**CITY PLAN COMMISSION****FILE NUMBER:** PLAT-25-000149**THURSDAY, January 15, 2026****SENIOR PLANNER:** Hema Sharma**LOCATION:** Lovers Lane at Taos Road, southwest corner**DATE FILED:** December 17, 2025**ZONING:** PD 326 (Area C)**PD LINK:** <https://dallascityhall.com/departments/city-attorney/Articles/PDF/Article%20326.pdf>**CITY COUNCIL DISTRICT:** 6**SIZE OF REQUEST:** 0.533-acres**APPLICANT/OWNER:** Lovers Lane Properties, LLC

**REQUEST:** An application to replat a 0.533-acre tract containing all of Lots 4 and 5 in City Block B/4991 to create one lot on property located on Lovers Lane at Taos Road, southwest corner.

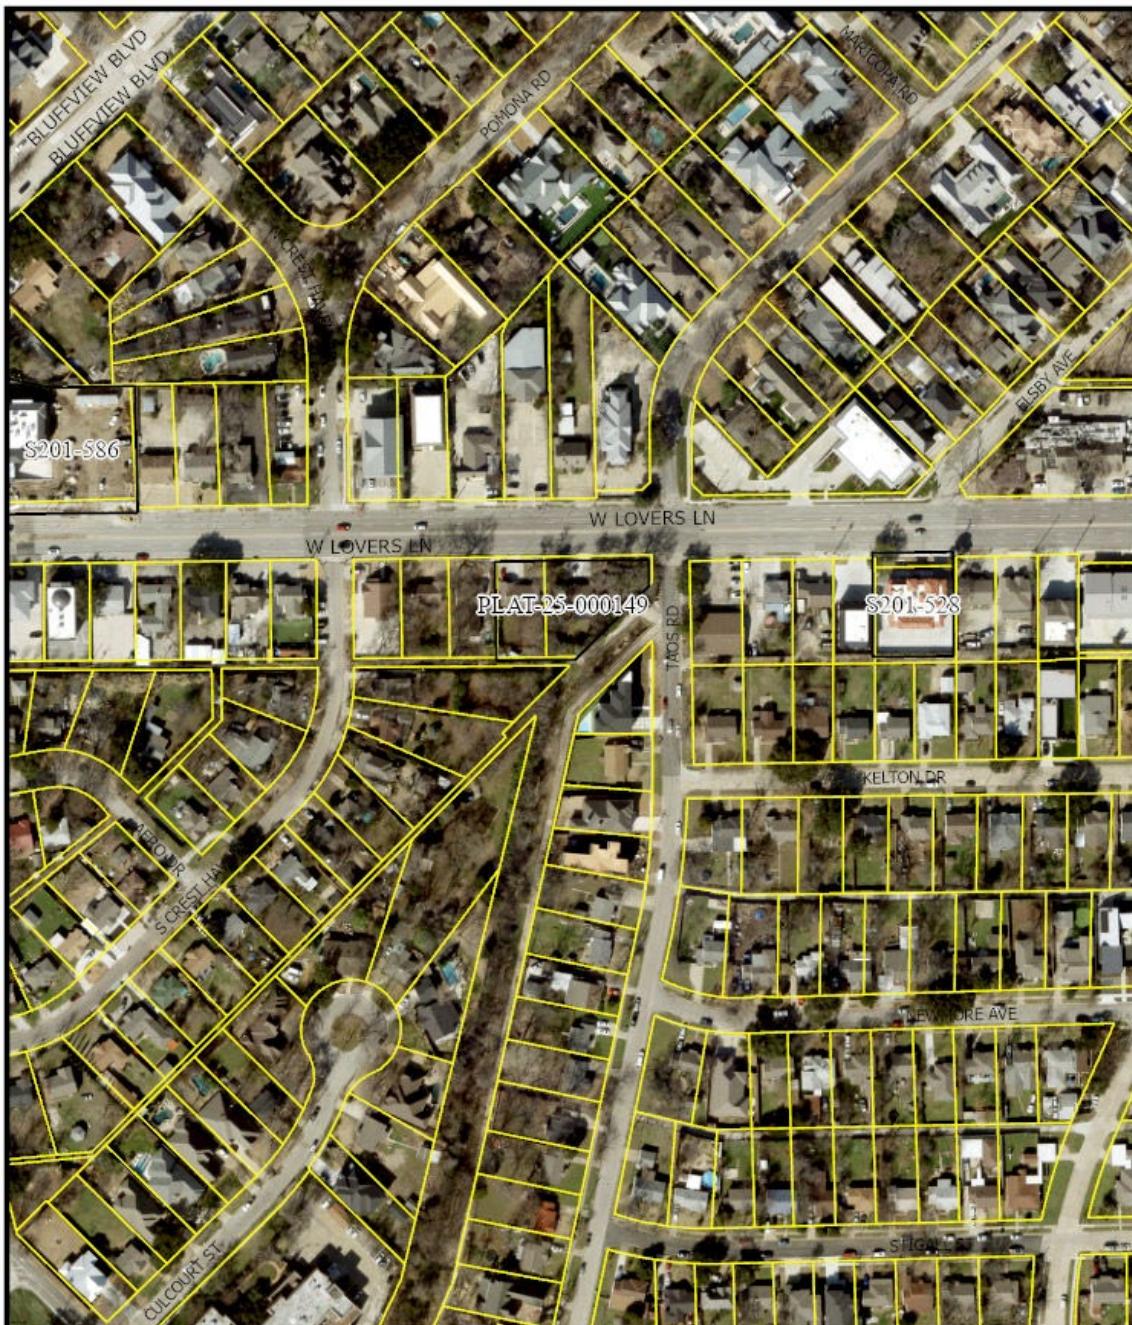
15. On the final plat, dedicate 45 feet of right-of-way (via fee simple) from the established center line of Lovers Lane. *Section 51A 8.602(c)*
16. On the final plat, dedicate 7.5 feet of right-of-way (via fee simple) from the established center line of an alley. *Section 51A 8.602(c)*

17. Prior to final plat, submit a completed final plat checklist and all supporting documents.
18. On the final plat, show recording information on all existing easements within 150 feet of the property.

19. On the final plat, show all additions or tracts of land within 150 feet of the property with recording information. Platting Guidelines.

22. Additional design information needed to complete review. Provide a brief description of the proposed project and a copy of the site plan to [daniel.silva1@dallas.gov](mailto:daniel.silva1@dallas.gov) to determine street lighting requirements.
23. On the final plat, add "Crest Haven Road" to plat drawing
24. On the final plat, identify the property as Lot 4A in City Block B/4991.
